4. TITLE AND SUBTITLE
ONPOST/OFFPOST GROUND/SURFACE WATER MONITORING PROGRAM, TASK 44, FINAL
TECHNICAL PLAN

ENVIRONMENTAL SCIENCE AND ENGINEERING
DENVER, CO8. PERFORMING ORGANIZATION
REPORT NUMBER

ROCKY MOUNTAIN ARSENAL (CO.). PMRMA
COMMERCE CITY, CO10. SPONSORING/MONITORING
AGENCY REPORT NUMBER

8.1 GROUND_WATER	8-1
8.2 SURFACE_WATER	8-4
9.0 REFERENCES	9-1
APPENDIX A--COMMENTS AND RESPONSES TO THE DRAFT FINAL TECHNICAL PLAN, NOVEMBER 1987	
APPENDIX B--TASK 44 FINAL LETTER TECHNICAL PLAN, FEBRUARY 10, 1988 AND COMMENTS AND RESPONSES TO THE DRAFT FINAL LETTER TECHNICAL PLAN, APRIL 29, 1987

Figure 9
PROPOSED TASK 44 ON-POST ALLUVIAL MONITORING
WELL NETWORK AND INFERRED
BEDROCK PALEOCHANNELS
SOURCE: HLA, 1987

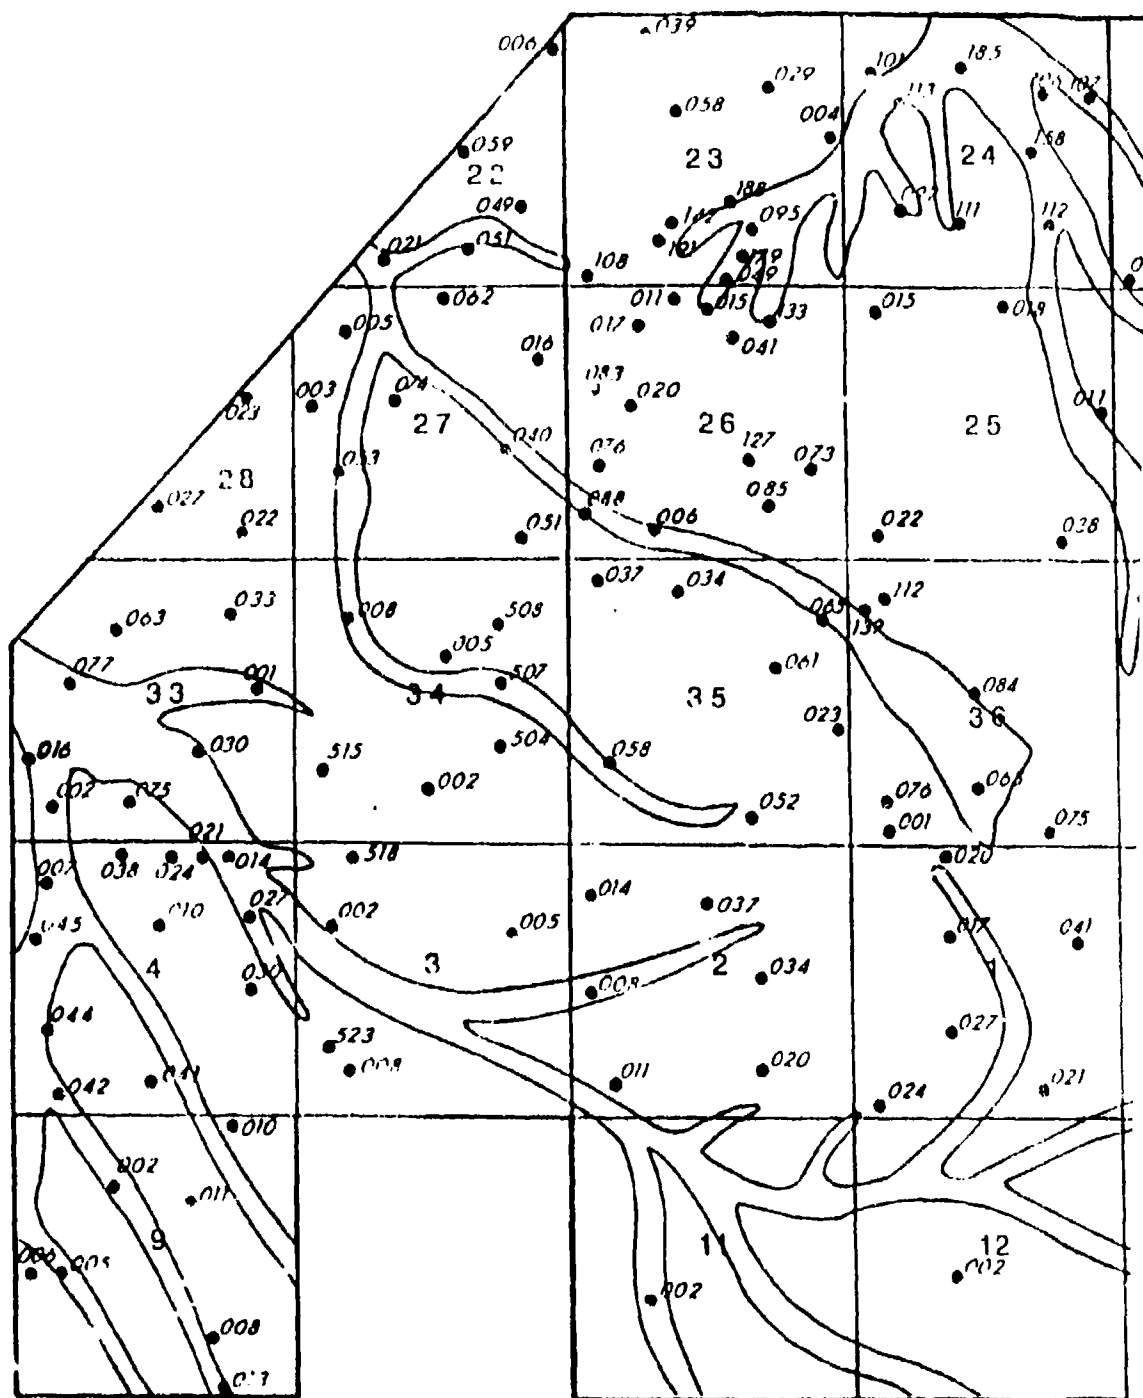
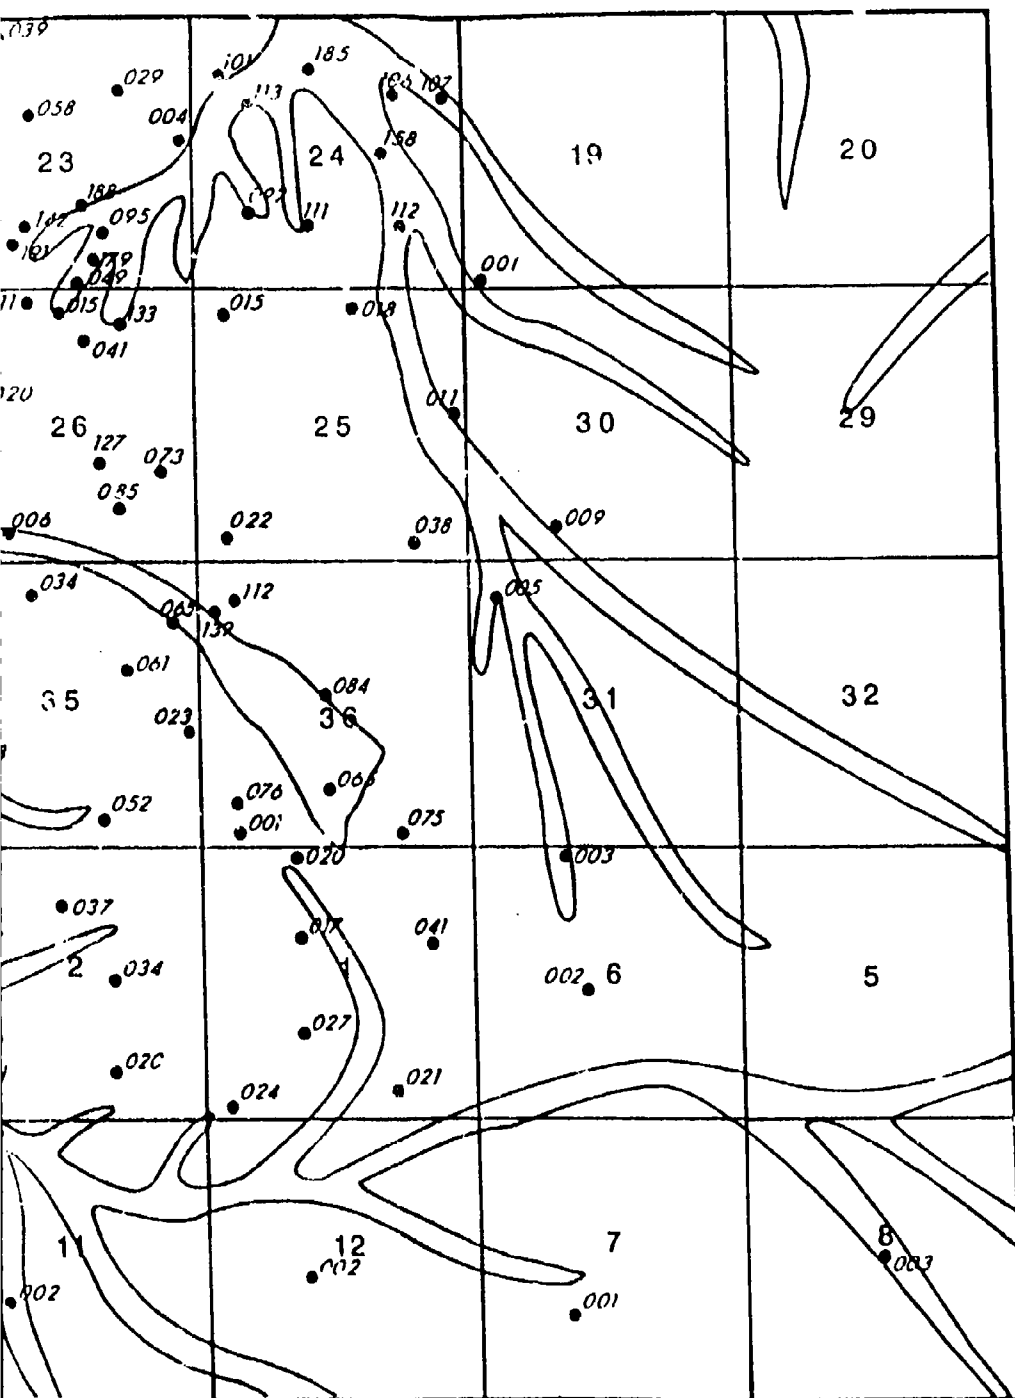
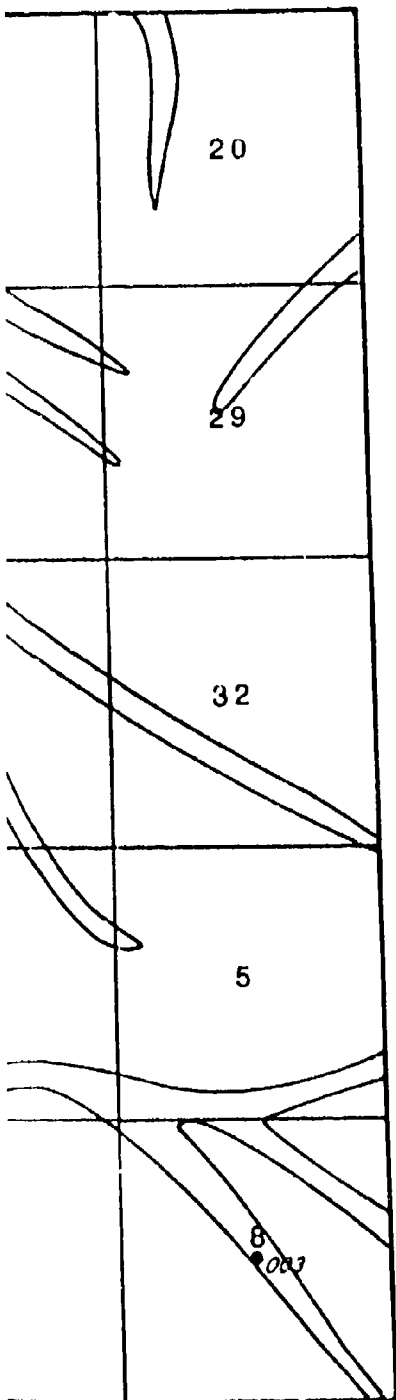
P.11 A comparison of Figures 5 and 9 indicates that the paleochannel map was prepared using excessive extrapolation. For example, Figure 9 shows three separate northwest trending channels beneath Sections 4 and 9 based on two data points (09002 and 09005) within a "channel." There is not a single data point in the northernmost channel (shown to extend for 1-1/2 miles). Similarly, in Section 3 and other areas where paleochannels are shown, little or no data exists to establish the location and orientation of the channels. The Task 44 program should not be focused on "inferred" or imagined channels. The monitoring well network and these figures should be modified accordingly.

Inferred bedrock paleochannels were not constructed based on the data points (well locations) shown on Figure 9. As stated on Page 11 of the Letter Technical Plan, the paleochannel map was prepared from available geologic information. This information included boring logs, bedrock contour maps, and alluvial thickness maps. Therefore, the locations of
